UNITED STATES PATENT AND TRADEMARK OFFICE

APPLICATION NO.	FILING DATE	FIRST NAMED INVENTOR	ATTORNEY DOCKET NO.	CONFIRMATION NO.
10/597,424	07/25/2006	Rainer Garger	HRG-PT040 (G 596pct/us)	1795
3624	7590	11/07/2008	EXAMINER	
VOLPE AND KOENIG, P.C. UNITED PLAZA, SUITE 1600 30 SOUTH 17TH STREET PHILADELPHIA, PA 19103			BENVENUTI II, MATTHEW GEORGE	
ART UNIT		PAPER NUMBER		4159
MAIL DATE		DELIVERY MODE		11/07/2008 PAPER

DETAILED ACTION

FIG.4

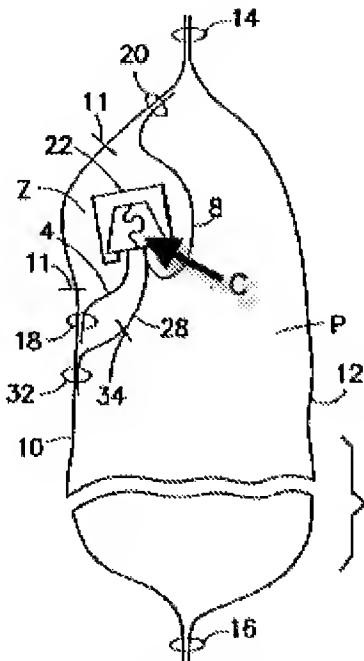
5. In re Claim 1, Schneider et al teaches a re-sealable bag comprising a closure (C) attached in an interior thereof (Z) to one of the front or rear walls (10, 12), with the closure (C) comprising two closure parts (4, 28), which are at a distance from a connecting or latching area of the closure (C), which forms a connection to the wall (10, 12), and having free edges that are connected undetachably to the wall (18, 32) and with a safety strip (the part of the front wall between 11 and 11) above an opening above the latching area of the closure (C), the safety strip (the part of the front wall between 11 and 11) is configured so that it can be separated from the wall before an

initial opening for exposing the opening ([0033], Lines 10-13), both of the closure parts (4, 28) are connected to the wall (10) underneath the opening and a cover sheet (8) is attached to the inner one of the closure parts (28) and also to the wall (10) above and to a side of the opening ([0032], Lines 8-13).

7. In re Claim 3, Schneider et al further teaches a bag wherein a lower edge of the cover sheet is fixed undetachably at the inner closure part (Figure 4, 8 attaches to 28)

8. In re Claim 4, Schneider et al further teaches a bag wherein the lower edge of the cover sheet is fixed directly on or at a distance to an inner grooved closure (Figure 4, 8 attaches to 28 at a distance to the inner grooved closure (C).
